Technical Bulletin

Number 186

February 20, 2007

AD-120 and AD-170 Panel Assembly (800F Series Shown)

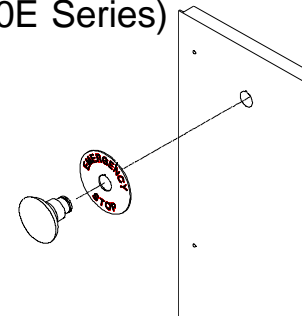
Nature of Change: E-Stop Push Pull Button Change

Due to compliant restrictions, manufacturer of the Emergency Stop has changed from an 800E series to an 800F series E-Stop button arrangement. As a result of this change, the related contact blocks have changed as well.

Below are the related front panel assemblies. The sheet metal panel itself has not changed, only the assembly has changed due to this E-Stop button arrangement change.

CHANGE FROM			CHANGE TO		
No.	P/N	Description	P/N	Description	
2	123500	Large Mushroom Head E-Stop Button Switch	123550	E-Stop Button Switch	
3	123506	Emergency Stop Nameplate	123506	Emergency Stop Nameplate	
4	123516	N.O. Contact Block	123566	N.O. Contact Block	
5	123521	N.C. Contact Block with Base	123751	N.C. Contact Block with Base

Comments: The current F and previously used E series E-Stop parts are not interchangeable. The nameplate is the only part that is. ADC still has a stock of the E series E-Stop parts available for replacement parts orders. Once these parts are gone, to convert to the F series, the E-Stop button switch and contact blocks must be changed as well. This also includes parts orders for the previous E series front panel assemblies listed.

Earlier Vintage Solaris Lint Screens

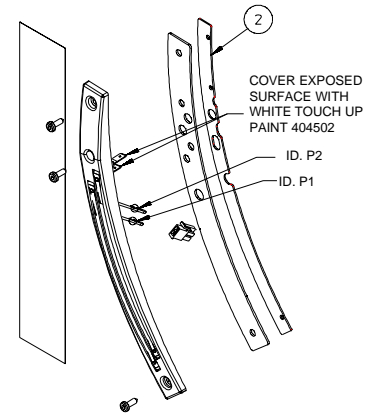
Earlier models of the SL20, SL2020, SL31 and SL3131 (and related OEMs) were manufactured with a finer/smaller mesh lint screen material, and secondary lint screen, which depending on the facilities installation, maintenance, and the use of "fabric softener sheets" can cause the primary lint screen to clog and be difficult to clean.

For units in the field with this finer/smaller mesh lint screen, they can be upgraded to a different lint screen (304 stainless steel material) with larger holes, which will reduce the amount of maintenance to keep the screen clean. However, when this screen is used, the secondary lint screen must be removed, and in addition, a lint prevention device be added to the lint box blower assembly.

IMPORTANT: Failure to use this lint prevention device will cause premature component failure that will not be covered under warranty. If you're not sure if your dryers have this latest lint screen and lint prevention device, or if you require this lint screen upgrade and lint device, contact the ADC service department with the model and all serial numbers of the dryers in question.

NOTE: When the latest/upgrade lint screen and lint prevention device is used, the "secondary lint screen" must be removed.

Control Board Cover

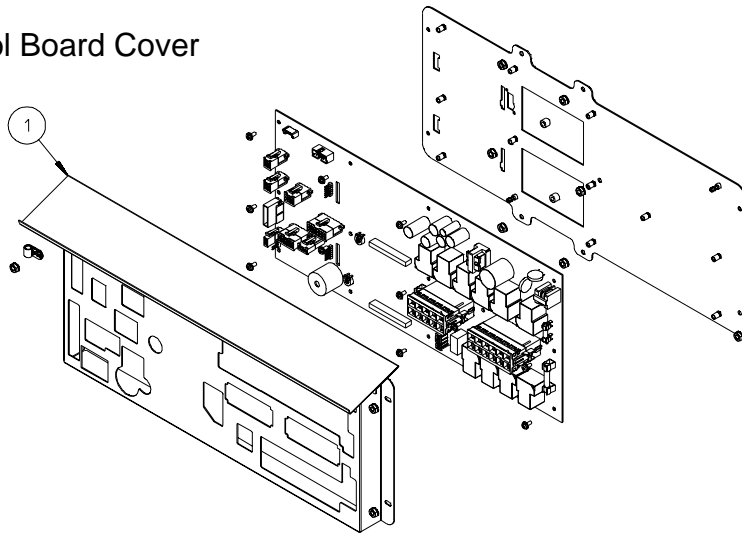
Nature of Change: The Phase 8.4 (8.2) control board cover (Illus. No. 1 in drawing) has been redesigned in an effort in standardization, so one cover can be used for various applications.

CHANGE FROM			CHANGE TO		
Qty.	P/N	Description	Qty.	P/N	Description
1	319187	Phase 8.4 Control Board Cover	1	319009	Solaris Control Board Cover
PSFs or assembly numbers affected by this change					
818899 – SL2020, SL2929 PH8.4 Coin Control Panel			819719 – SL2020, SL2929 PH8.4 Coin S/S Control Panel		
819326 – SL2020, SL2929 PH8.4 Non-Coin Control Panel			819587 – SL2020, SL2929 PH8.4 Non-Coin Control Panel		
CHANGE FROM			CHANGE TO		
Qty.	P/N	Description	Qty.	P/N	Description
1	319333	MLG33 Phase 8.2 Control Board Cover	1	319009	Solaris Control Board Cover
Assembly number affected by this change					
819310 – SL3131 Maytag PH8.225 Cent Control Door Assembly					
CHANGE FROM			CHANGE TO		
Qty.	P/N	Description	Qty.	P/N	Description
1	319337	ADC Phase 8.4 Control Board Cover	1	319009	Solaris Control Board Cover
PSFs or assembly numbers affected by this change					
819504 – SL3131 ADC PH8.4 25 Cent Coin Control Door Assy			819625 – SL3131 PH8.4 Euro GBP Prg Cntrl Panel Assy

Comments: The current control board cover (ADC P/N 319009) is a direct replacement for the previously used cover (ADC P/N 319187 or ADC P/N 319337). Any parts

order placed for the previously used cover (ADC P/N 319187 or ADC P/N 319337) will be cross-referenced and filled with the current cover (ADC P/N 319009).

Lint Door/Hatch Change

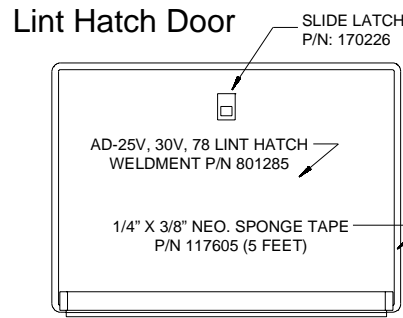
Nature of Change: Lint (hatch type) door seal sponge gasket has changed from 1/8" to 1/4" to provide for a better seal.

CHANGE FROM			CHANGE TO		
Qty.	P/N	Description	Qty.	P/N	Description
5	117604	1/8" Thick x 3/8" Wide Neo. Sponge Tape	5	117605	1/4" Thick x 3/8" Wide Neo. Sponge Tape
Assembly numbers affected by this change					
802265 – AD-25V, AD-30V, AD-78 Coin Lint Hatch Assembly 802277 – AD-30V, AD-78, D40, CG3040 Drop Lint Door Slide Hatch Assembly

Comments: Current 1/4" gasket can be used as a replacement in the field for previous models manufactured with the 1/8" gasket.
